RE: Urban Lot Split-Preliminary Parcel Map No.:
ADM-2023-4420-PMUL
Address: 21340 Chase Street
Community Plan: Chatsworth - Porter Ranch
Zone: RA-1
Council District: CD 3 - Blumenfield

LETTER OF COMPLIANCE – Ministerial Review of SB 9 Urban Lot Split

TENTATIVE PARCEL MAP NO. ADM-2023-4420-PMUL

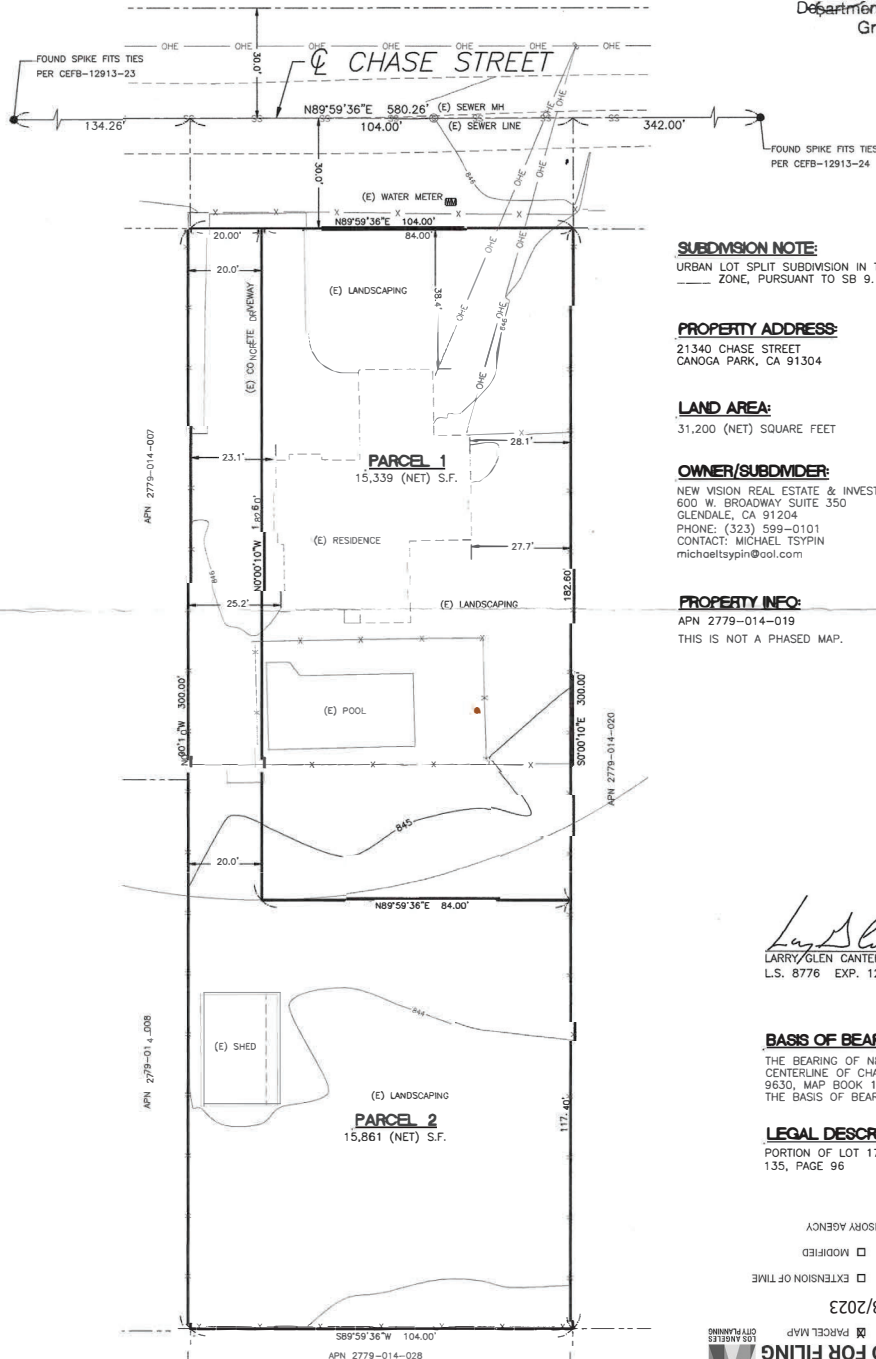
- a. Show location of all parking spaces and access driveway for the proposed Parcel 1. The required driveway access is not located within its own lot. Obtain a building alteration permit to relocate driveway or to remove the existing parking spaces and driveway per SB 9 parking exceptions. Provide a copy of building permit and signed inspection card to show work has been completed.

- b. Obtain permit for the demolition or removal of existing storage shed under permit 1991LA76861 on the proposed Parcel 2. Accessory structures and uses are not permitted to remain on lots without a main structure or use. Provide copies of the demolition permit and signed inspection card to show completion of the demolition work.

- c. Verify the location of existing swimming pool in the proposed Parcel 1 with permit 1960VN66421. The pool and pool enclosure shall be within the proposed Parcel 1. Show compliance with pool enclosure requirements per LABC sections 3109.2 and 3109.4.

- d. The proposed Parcel 2 shall provide a minimum 70 feet of lot with per LAMC 12.07 C.4. Revised the map or obtain approval from the Advisory Agency to approve the deviations from the Zoning code.

- e. Provide building plans to show compliance with current Los Angeles City Residential Code concerning exterior wall, opening protection and exit requirements with respect to the new property lines.
 - i. Provide 1-hr fire-resistance exterior walls if fire separation distance is less than 5' [T-R302.1(1)].
 - ii. Maximum 25% opening area is allowed when the fire separation distance is between 3' and 5' for building without automatic sprinkler. (T-302.1(1)).
 - iii. All noncompliance issues shall be corrected, required permits shall be obtained, and the final work inspected prior to a clearance letter being issued.
- f. Provide a copy of the draft final map to LADBS Zoning to obtain the final Zoning clearance.

- i. The project shall be permitted to deviate from the otherwise required 17,500 square foot minimum lot size of LAMC Section 12.07 (RA Zone) and provide lots of 15,339 for Parcel 1 and 15,861 square feet for Parcel 2.

- ii. The project shall be permitted to deviate from the otherwise required 70 foot minimum lot width and shall be permitted to subdivide using a flag lot

- iii. The project shall be permitted to deviate from the otherwise required minimum driveway width of 26 feet as required in the Letter from the Department of Transportation dated July 19, 2023 and instead provide a driveway width of 20 feet for Parcel B.

- v. The project shall be permitted a deviation from western side yard setback requirements for the existing single-family home. Three (3) feet shall be permitted in lieu of the otherwise required 10 feet pursuant to LAMC Section 12.07 (RA Zone).
